**CITY OF MERIDIAN
FINDINGS OF FACT, CONCLUSIONS OF LAW
AND DECISION & ORDER**

Case No(s). H-2026-0018

COMMUNITY DEVELOPMENT DEPARTMENT REPORT

SUBJECT: Summerlin AZ, PP & MDA
H-2026-0018

E. Preliminary Plat (date: 4/8/2026)

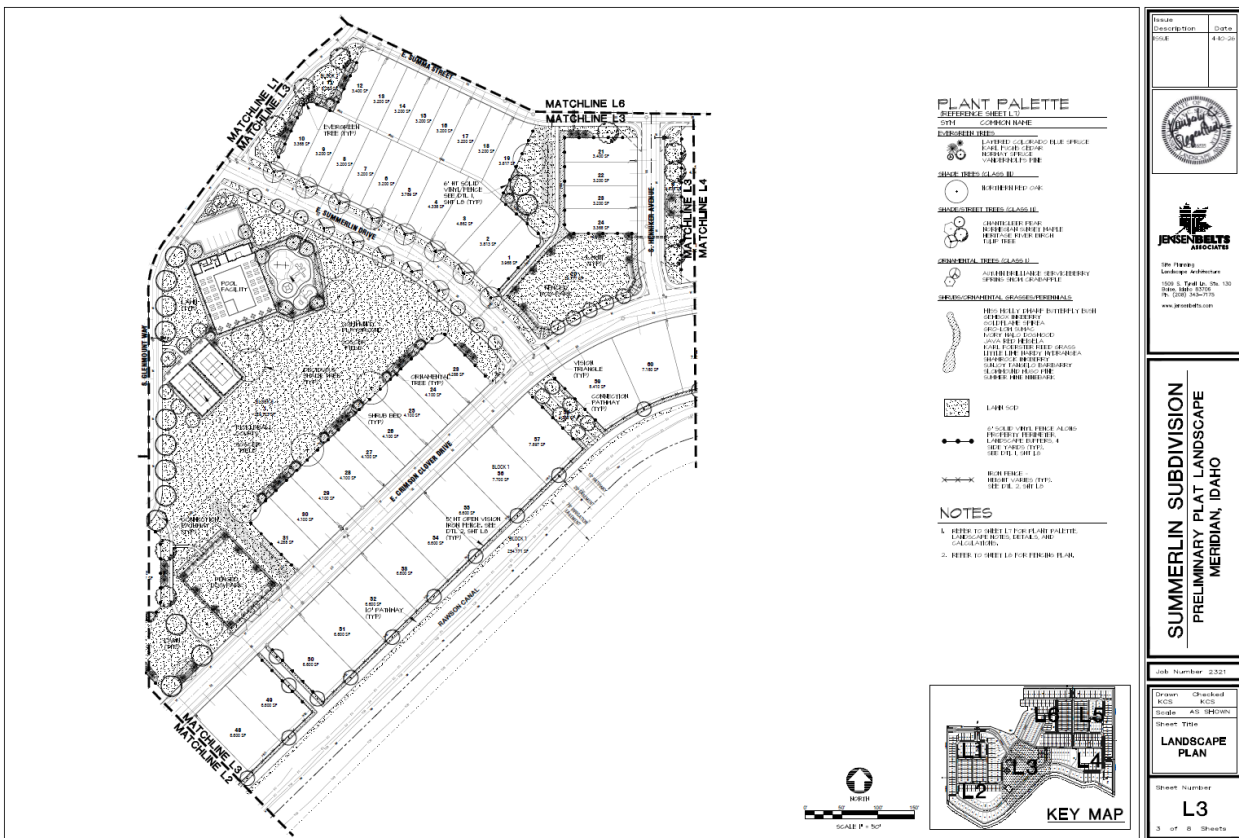
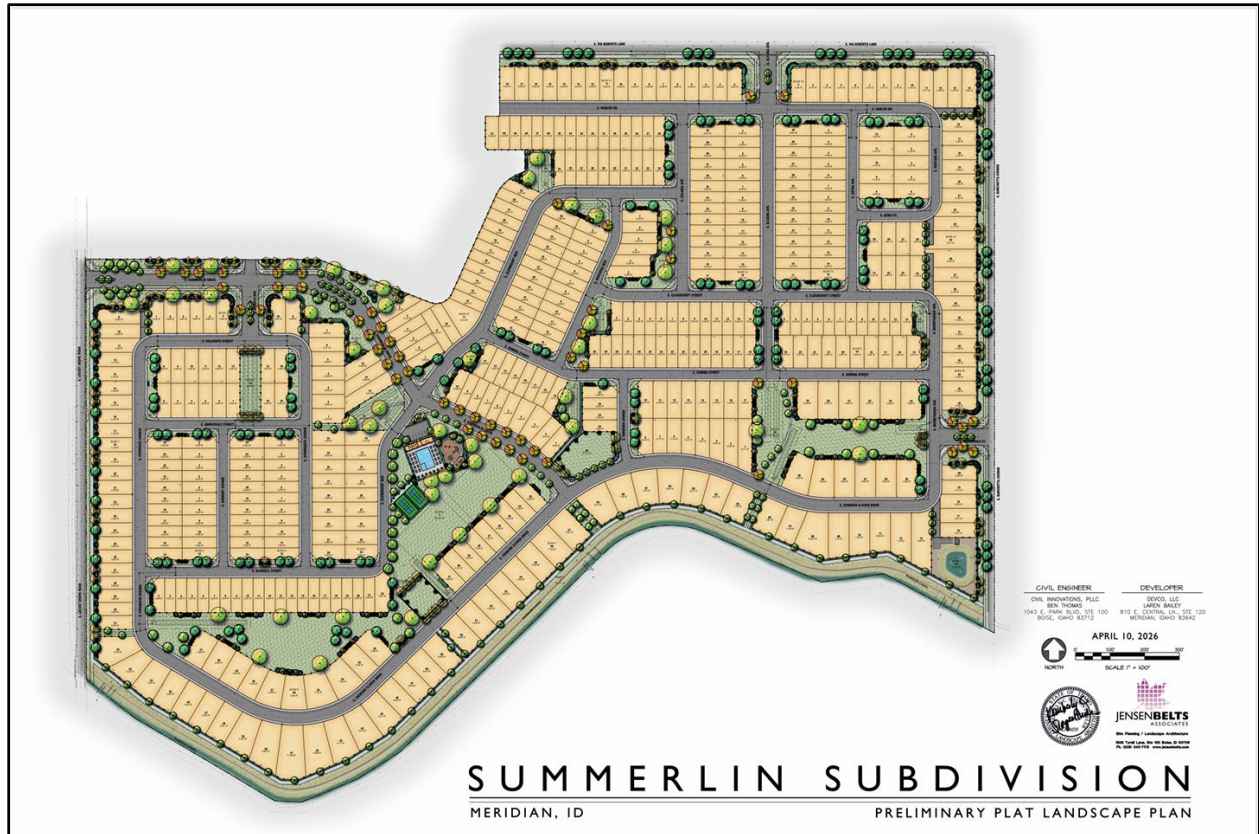
Staff is asking the Commission and Council to weigh in as to whether or not the applicant should revise the plat map to reconfigure Lots 4-7, Block 18 on the northeast side of E. Summerlin Drive so that Lot 9, Block 18 does not have 4 lots backing up to its side yard. Per Comprehensive Plan Policy 3.07.01A, require all new development to create a site design compatible with surrounding uses through buffering, screening, transitional densities, and other best site design practices.

2. The Preliminary Plat included in Section VII, dated 10/10/24, is approved with the following revisions:
- a. All utility easements reflected on the utility plan shall be included on the final plat.

- b. All pathways and micropathways shall be within a separate common lot or easement as required per UDC 11-3A-8.
 - c. ~~Revise the plat map to reconfigure Lots 4-7, Block 18 on the northeast side of E. Summerlin Drive so that Lot 9, Block 18 does not have 4 lots backing up to its side yard if required by Council.~~

- d. The applicant shall construct a 10-foot wide sidewalk along the west boundary of S. Recreation Avenue.
3. The Landscape Plan included in Section VII, dated 5/28/24, shall be submitted for review and approval with the following revisions prior to final plat approval:

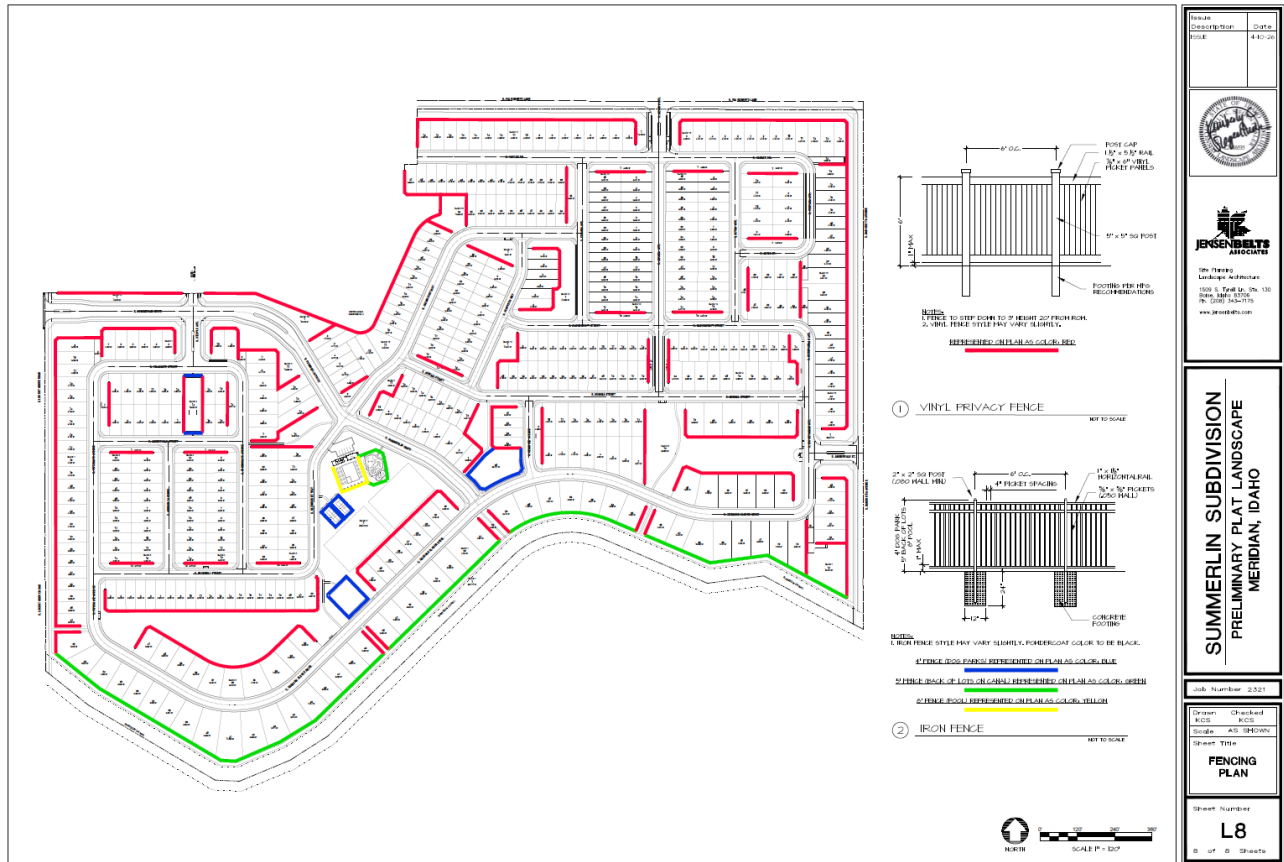
The applicant shall add a mitigation section to the landscape plan for trees meeting the criteria above that are removed.

Landscaping for pathways shall meet the requirements outlined in UDC 11-3B-12. The applicant is required to provide a landscape strip a minimum of five (5) feet wide shall along each side of the pathway. Designs are encouraged in which the width of the landscape strip varies to provide additional width to plant trees farther from the pathway, preventing root damage. The minimum width of the landscape strip shall be two (2) feet to allow for maintenance of the pathway. The landscape strips shall be planted with a mix of trees, shrubs, lawn, and/or other vegetative ground cover. The applicant is required to add pathway landscaping along the Rawson Canal.

- a. Show the ten (10) foot wide detached sidewalks along the east side frontage of Locust Grove Road and the west side frontage of S. Recreation Avenue.

- b. Remove a portion of the fence and provide a micro-pathway within Lot 24, Block 18 that connects to the pathway within Hadler No. 3 Subdivision Lot 25, Block 4.

- c. Add pathway landscaping along the south side of the Rawson Canal in accord with UDC 11-3B-12.
 - d. Add shrubs/ornamental grasses/perennials to the pathway within Lot 15, Block 5 and Lot 18, Block 8.
